REPLACEMENT SYSTEM VARIANCE REQUEST

M36L66B Town

Permit No. 2309 E

System's Location: 26 Buena Vista Drive (STREET)

SUBSURFACE WASTEWATER DISPOSAL PLAN

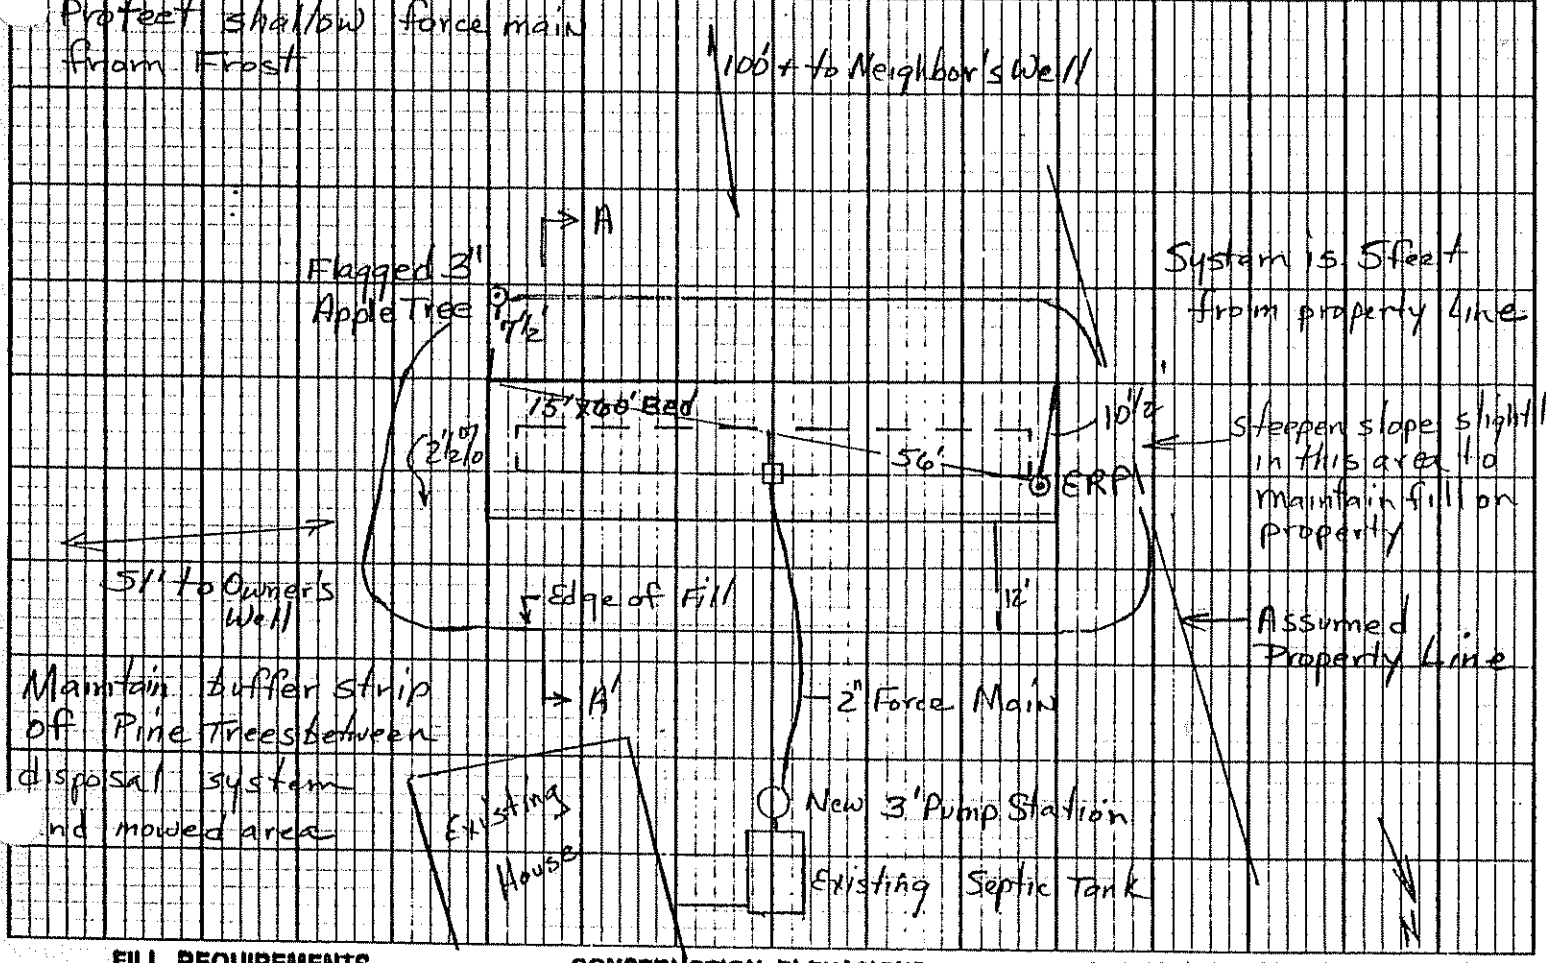
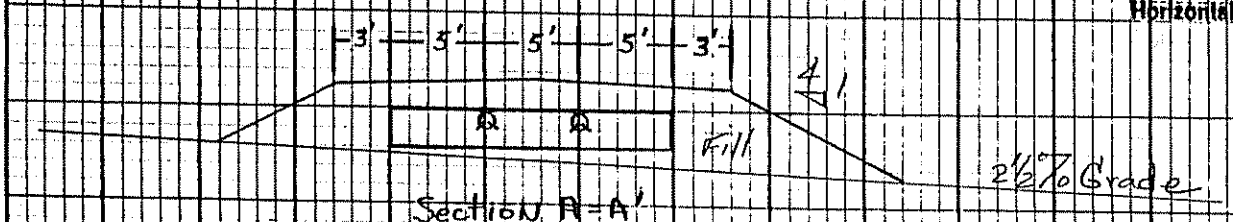
1. ~~Fill extension Grade — to 3:1~~ Steepen slope slightly less than 4:1 on one side
2. of disposal system to avoid placing fill on
3. neighboring property

☑ a. (☑ approve, ☐ disapprove) the variance request based on my authority to grant this variance. Note: If the LPI does not give his approval, he shall list his reasons for denial in **Comments** Section below and return to the applicant.
